Amended Site Plan

Case #: 21-11-12-PC

Applicant: Rivian

Summary: Proposed Amended Site Plan for 100 N. Rivian Motorway to permit an addition to the west side of the building, an updated lighting plan surrounding this addition, and installation of a comprehensive sign package.

SITE AMENDMENT

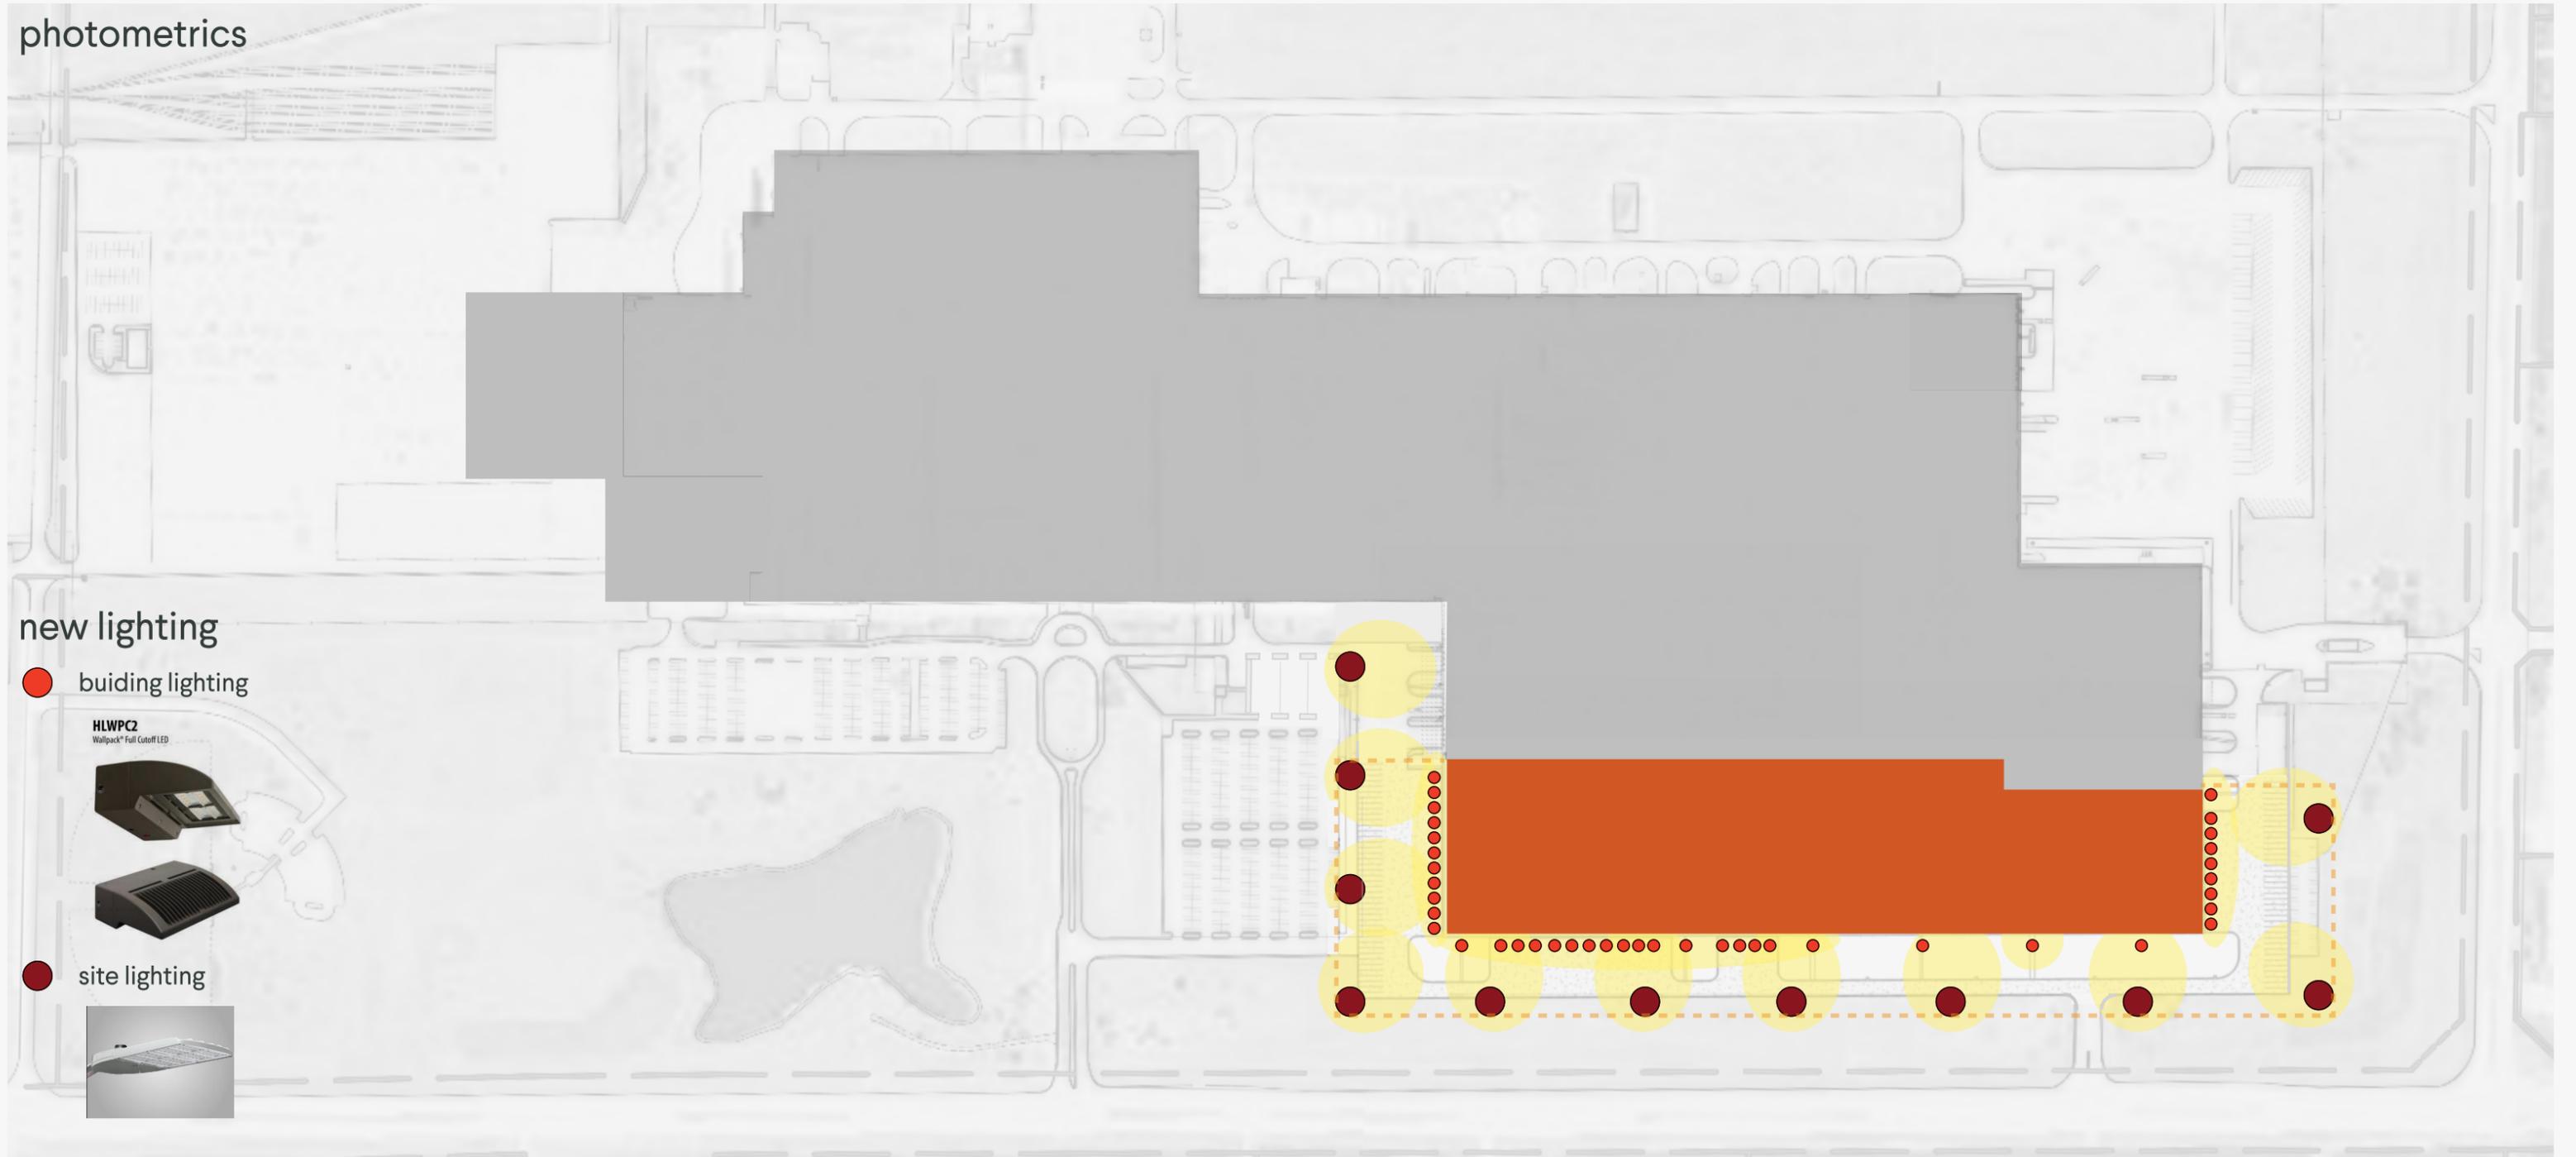
- 1. Building addition.** Rivian proposes a 623,000 square foot addition along the building's western side. The expansion would bring the total size of the facility to approximately 3.9 million square feet and would remove 218 parking spaces to the west. An additional 900 parking spaces are available to the facility's northeast, with Rivian buses available to transport employees between this lot and the building.

Town staff finds the proposed plan to meet the goals of Site Plan review. The proposed expansion is compatible with the existing structure and will largely occupy already-paved ground, with abundant parking available to compensate for the spaces lost.

SIGN DETAILS - B4.1/B4.2/B5 exterior wayfinding signage - normal plant - design intent for bidding 04/16/2021

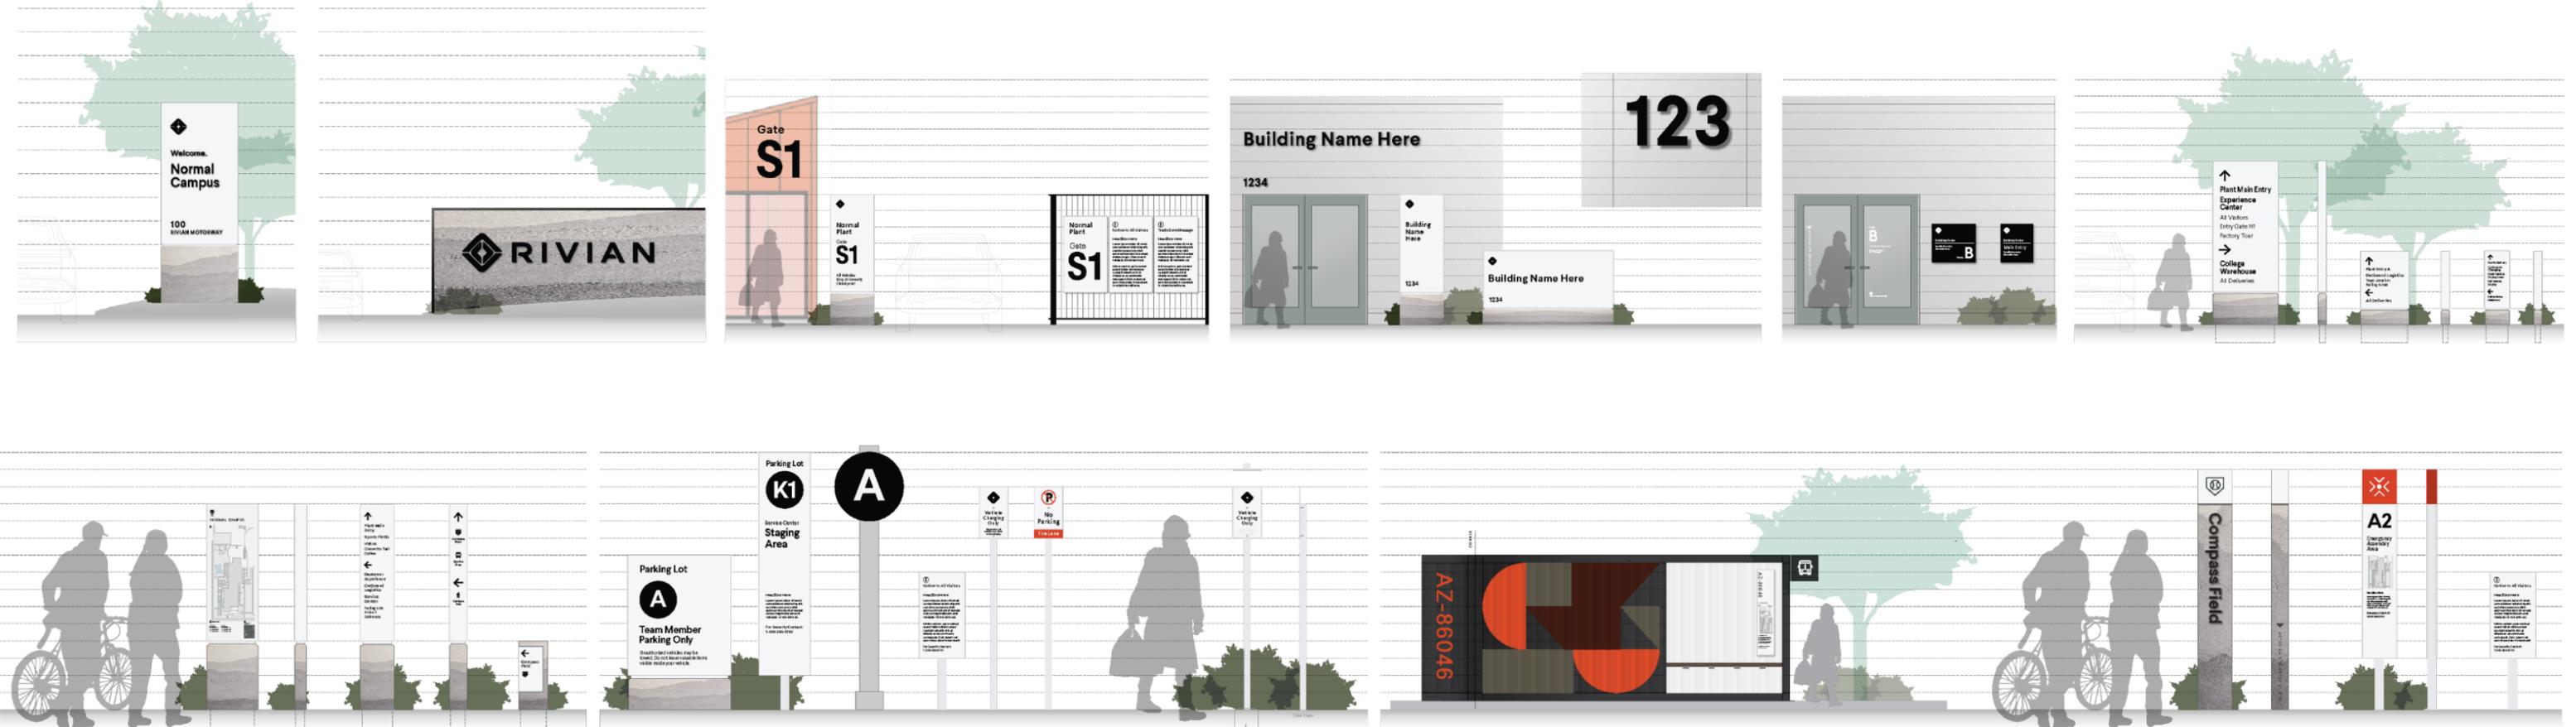
As stated above, seven categories of directional signs (or 213 individual signs) will require variances in order to be approved as proposed. Directional signage variances are typical of large institutional or commercial campuses, including Heartland Community College and the Carle BroMenn Medical Center.

1. Directional signage exceeding six feet in overall height (Sec. 15.13-7H)
2. Directional signage exceeding six square feet in area (Sec. 15.13-7H)
